### CO74 - Western Montgomery County Landowners Association

# 3. CONVERSION OF THE BRUSH MOUNTAIN INVENTORIED ROADLESS AREA (IRA) TO A WILDERNESS STUDY AREA

#### 4. DANGERS OF THE PIPELINE TO THE MOUNT TABOR AREA

Figure 3 The Nature of Karst Geology in the Mount Tabor Area

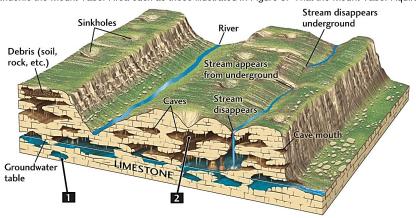
The Mountain Valley Pipeline (MVP) is shown as the medium blue line in Figure 1 with mile markers. That route is the October 2015 proposed route which was superseded on 15 October 2016 by a nearby route. Both routes pass through the Slusser's Chapel Conservation Site which is dangerously susceptible to damage from construction blasting and contamination from pipeline leaks during operation as well as fuel spills during construction. The reason for that susceptibility is the karst bedrock that over time has formed the deep, multi-layered, highly connected underground passages that constitute the aquifer supplying the water to hundreds of homes in the Mount Tabor area. The resulting general nature of karst in the Mount Tabor area is schematically represented in Figure 3.

The Mount Tabor Aquifer is made up of all the underground conduits, passages, and caverns that underlie the Mount Tabor Area such as those illustrated in Figure 3. That the Mount Tabor Aquifer is

CO74-8 Section 3.5 of the final EIS has been updated to provide additional information regarding alternative routes across the Mount Tabor Sinkhole Plain. Section 4.1 of the final EIS has been revised to provide additional details regarding karst features in the project area.

Figure 4 Karst Hydrology of the Slusser's Chapel Conservation Site

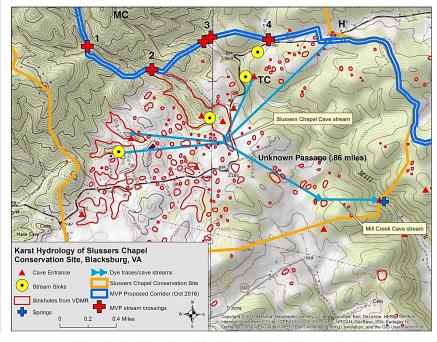
highly connected throughout the Mount Tabor area is vividly demonstrated with dye-trace studies shown in Figure 4. There, the 15 October 2016 MVP route is displayed as the parallel light-blue lines with red plus signs in four locations. Those locations are crucial points of the danger to the Slusser's Chapel Conservation Site because erosion and resulting sedimentation at those points would go to the Slusser's Chapel Cave which is the central underground feature of the Mount Tabor Aquifer. That is, all underground passages and streams such as Mill Creek lead to the Slusser's Chapel Cave! Points 1 and 2 are crossings of a stream that is the convergence of three streams running down the south slope of Brush Mountain. That stream is fast-running and very turbulent during heavy rains and carries sediment from erosion directly to Slusser's Chapel Cave. Point 3 is the crossing of Mill Creek which also is fast-running and turbulent during heavy rains. Point 4 is the crossing of two tributaries of Mill Creek that are milder streams than those at the first three points. Thus, the extra sediment caused by pipeline construction and use that is carried to Slusser's Chapel Cave could contaminate or even clog the cave. The point is that the 15 October 2016 MVP route presents significant danger to all regions of the Mount Tabor Aquifer because the area is so highly inter-connected by many, many *unknown* underground conduits of water flow. Moreover, the pipeline company has no idea where new sinkholes will develop along the route. In fact, new sinkholes develop on an almost yearly frequency in this karst area. The Mount Tabor area residents all rely on the Mount Tabor Aquifer as their sole source of water! Thus, we cannot afford to have the aquifer be contaminated or destroyed.

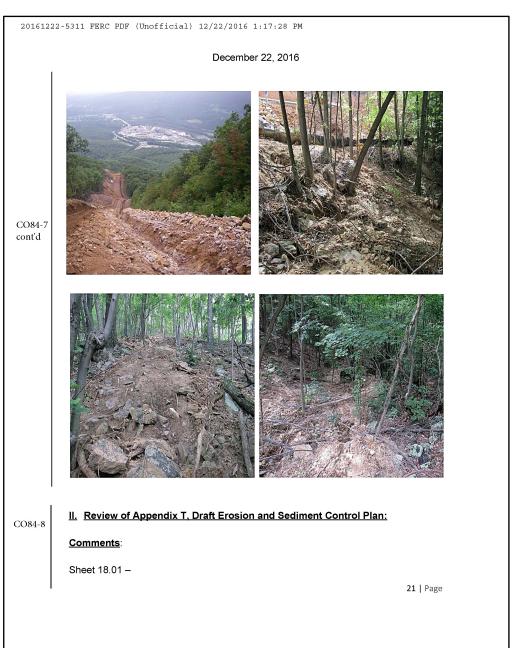
A case Study for a 12 inch pipeline constructed in Giles County, VA demonstrates one case of a pipeline construction with severe erosion control problems. The pipeline was built in 2014 and the pipeline corridor is still not vegetated. The contractor did not install an adequate number of erosion control devices or maintain the erosion control devices that were in place. An intense rain event occurred when the pipeline corridor was bare and the erosion control measures were not adequate to prevent soil from eroding downslope. Mud flowed down the mountain side into streams at the bottom of the slope. Additional work was required to restore the impacted streams. Contractor negligence and inadequate erosion control devices on steep slopes was a cause for the failure.

These photos were taken during construction of the 12 inch pipeline in Giles County, VA, near the proposed route of the Mountain Valley Pipeline. This case is focused on a section of the pipeline that crosses Peters Mountain in the Jefferson National Forest. The agencies with primary regulatory responsibility for this part of this pipeline project are the Forest Service and the VA DEQ. It would be reasonable to expect that the highest standards of performance and regulatory oversight would apply to a pipeline construction project on national forest land. Instead, this case study provides substantial evidence of both careless construction practices and regulatory system failure.

CO84-8 Erosion control measures would be employed as specified in the FERC's Plan.
